REVISED CTL DECISION SHEET

Standard(s) (incl. year)	Subclause(s)	No.	Year
IEC 60950-1:2005 IEC 60950-1/A1:2010 IEC 60950-1/A2:2013	1.5.9.4	DSH 0794A	2013
Category			
OFF			
Subject	**Keywords**	**Developed by**	**To be approved**
Requirements of subclause 1.5.9.4 of IEC 60950-1:2005 and IEC 60950-1:2005/A1 for combinations of varistors (VDR) and gas discharge tubes (GDT)	- Varistor - Gas discharge tube - Earthing	ETF2	2014 CTL Plenary Meeting

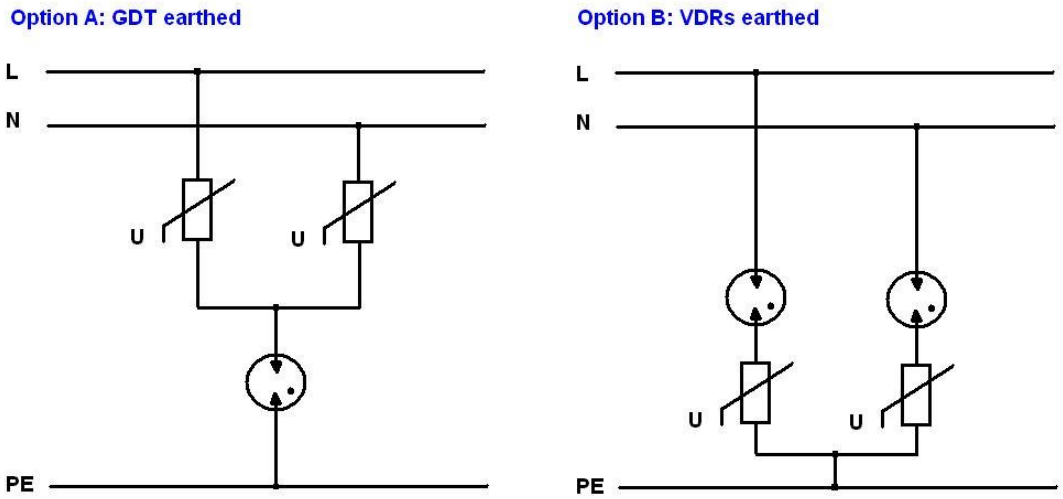
Is it relevant in series connections of VDR+GDT, which component is connected to PE?
See circuit diagram below.

a) Two examples with different components connected to PE:
- Option A with the GDT connected to PE
- Option B with the VDRs connected to PE

IEC 60950-1/A2 sub cl. 1.5.9.4 shall follow.

In both options, the combination of VDR+GDT is connected to PE.
